## Dimensions between eyepieces in head

Please find attached two pictures of the inside of the Prima DNT ergo head.

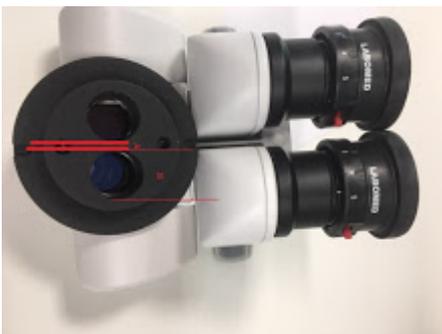
I ask documentation about STEREO BASE of Prima DNT. Please see Leica M320 - Stereo base 24 mm.

I ask manufacturer technical documents for tender, that distance between eyepieces is 23 mm. see photo.

If I calculate, the heart distance between the two circles is 22 mm.

Dimension A is 3 mm

Dimension B is 19 mm

Two times half the circle (B) is  $2 * 9,5 \text{ mm} = 19 \text{ mm}$  plus A (3 mm) makes 22 mm.
